Component Identifiers:

Dealer Inventory Instructions

Figure 1. Engraved Rotor Part Number

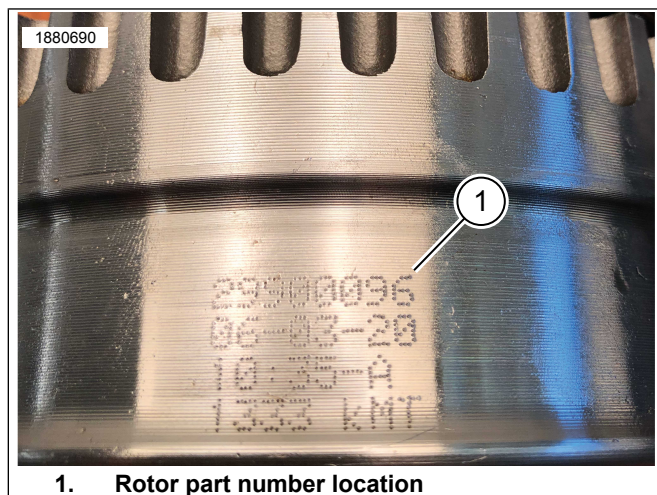
- See Figure 1. The rotor part number (1) on outer diameter of component.

Figure 2. Engraved Stator Part Number

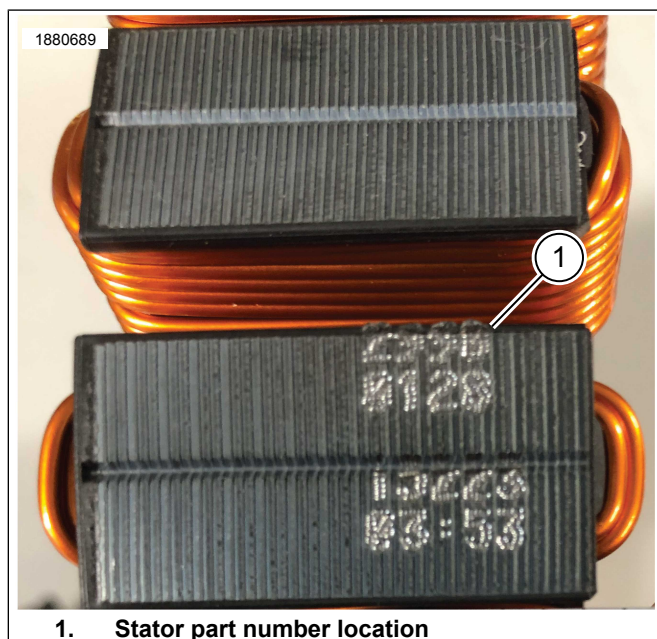
- See Figure 2. The stator part number (1) on outer diameter of component. The first line is the first portion of the part number. The second line is the remainder of the part number.

Figure 3. Coolant Manifold Designator

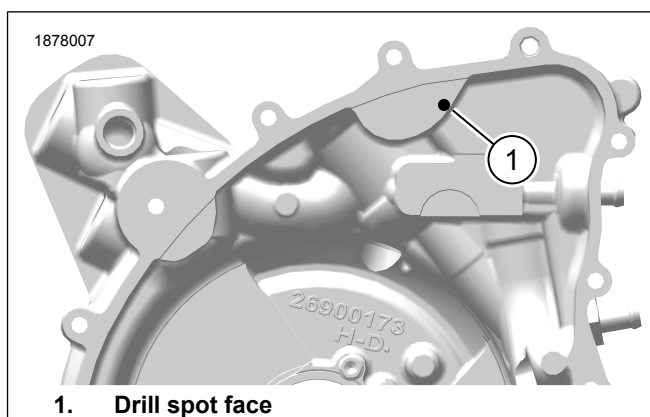
- See Figure 3. The 2024 cooling manifold has a single drill spot face (1) on the inside pad of the component.
